Evaluation of Cost Data

South Coast Air Quality Management District (SCAQMD)

PROJECT REPORT		
	Document No.: 19-9009-017		
	NEC Project No.: AQMD-19-9009		
	Date: 6/14/2021		
		Rev: 2	
Client:	South Coast Air Quality Management District (SCAQMD)		
Project:	Proposed Rule 1109.1 NOx BARCT Review		
Subject:	Evaluation of Cost Data

Figure 1: TIC cost for ULNB upgrades on heaters and boilers > 40 MMBtu/h

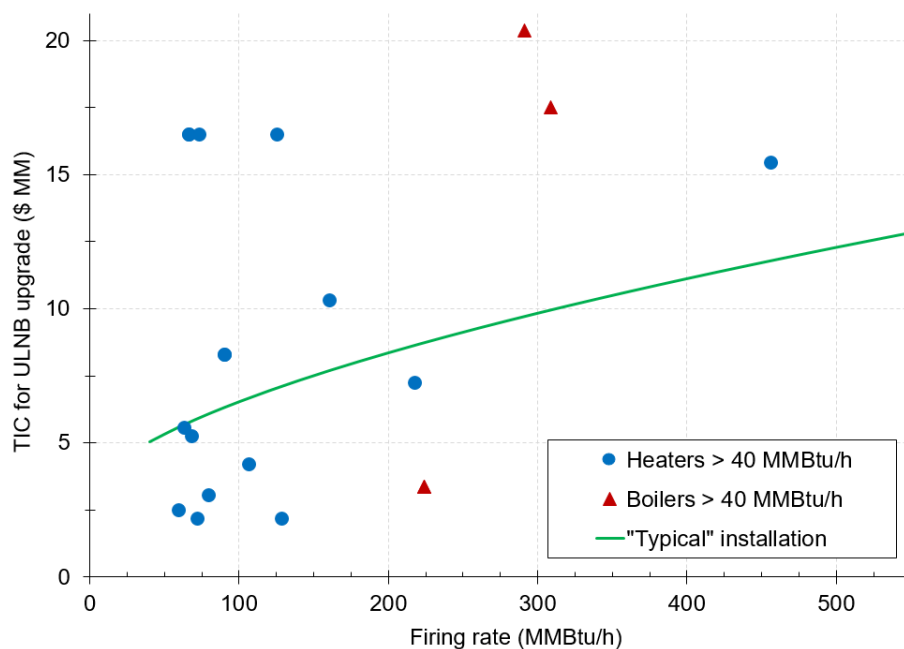
Representative installations from NEC’s experience list were used to generate a TIC and prorated costs were obtained from a 0.6 power law function based on firing rate. If a CEMS is required then \$0.5 MM should be added to the curve. The three points in Figure 1 at \$16.5 MM for heaters < 200 MMBtu/h is high for a typical ULNB upgrade project. Without scope definition it is difficult to compare these TICs against “typical” ULNB upgrades. It is worth noting these high estimates are for coker heaters. A coker heater can have:

This can increase the complexity factor over a “typical” heater upgrade. However, NEC cannot say with certainty what is driving these particular TIC estimates without scope definition, particularly given another refinery provided a TIC estimate that is almost \$10 MM lower for ULNB upgrades on a large coking heater.

Other outlying data points on Figure 1 include boilers in the 300 MMBtu/h range. When upgrading the burners on a boiler there may be additional considerations including:

Without scope definition it is difficult to ascertain if a complexity factor should be applied to these units.

Recent discussions with Clearsign™ indicate the cost of the CORE burner, considered a leading candidate in the next generation of emerging ULNB technologies, will run in the \$100,000+ range per burner. Current ULNBs cost around one-tenth of this per burner. If the Clearsign™ CORE will become the basis for burner upgrades in future projects then NEC would expect the “Typical” installation curve shown in Figure 1 to move significantly higher.

Figure 2: First submission of TIC estimates for SCR retrofits on heaters and boilers > 40 MMBtu/h

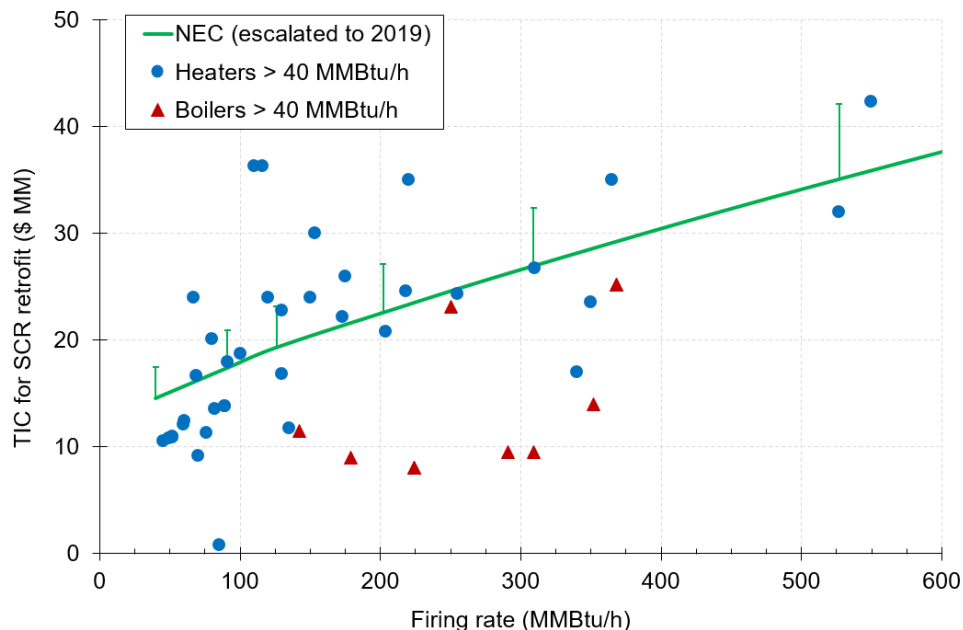
Figure 2 shows the escalated NEC estimate roughly passes through the middle of the data obtained from refineries for the first submission of TIC estimates. The NEC estimate from 2014 was based on:

Error bars on the NEC estimate accounts for a 20% allowance on heaters and boilers where the SCR is difficult to install (i.e. represents a complexity factor). From the 49 TIC estimates that were obtained, 5 appear significantly higher than NECs escalated estimate.

Figure 3: Second submission of TIC estimates for SCR retrofits on heaters and boilers > 40 MMBtu/h

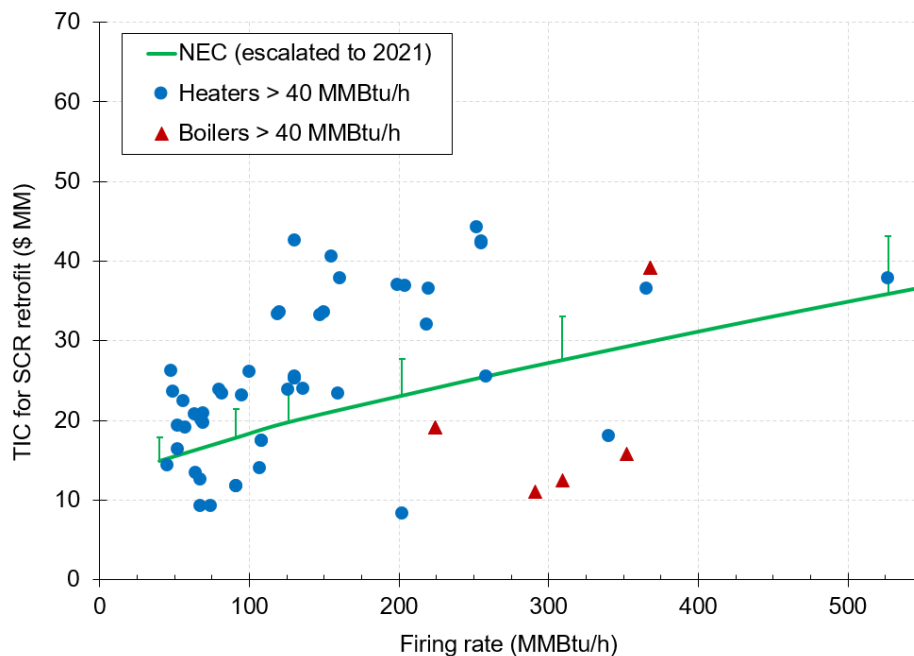
see Figure 3. Figure 3 shows the escalated NEC TIC is now at the lower end of the data obtained from refineries. From the 62 TIC estimates that were obtained, 15 now appear significantly higher than NECs escalated estimate.

Figure 4: Ratio of first-to-second submission TIC estimates where both were available for heaters and boilers

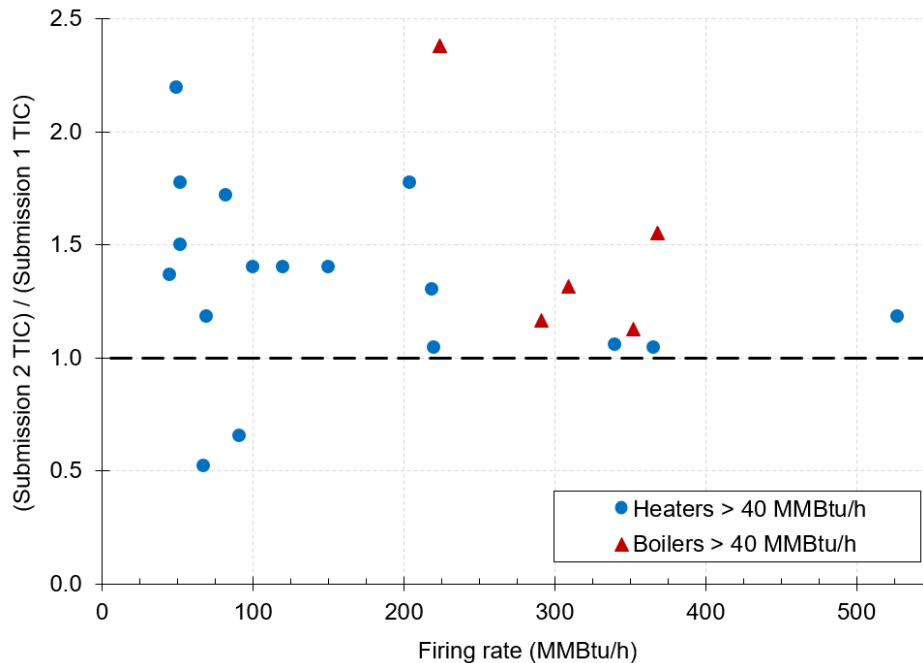
Figure 4 compares the ratio of second submission TIC estimate divided by the first submission TIC estimate for heaters and boilers where both were available. While two heaters in the district had a lower price in the second submission, the majority of units all went through a TIC increase on the second submission.

An increase in the TIC is not unusual as project scope becomes more clearly defined through the latter stages of engineering. During conceptual engineering phases it is typical for the contingency on a TIC estimate to be in the +50% range to address any complexity factors that have not yet been identified. As detailed engineering progresses the uncertainty associated with complexity factor is replaced with defined scope that can be estimated. In many cases it is not easy to address complexity factor until engineering is performed. Items related to the complexity factor that impact a TIC estimate include:
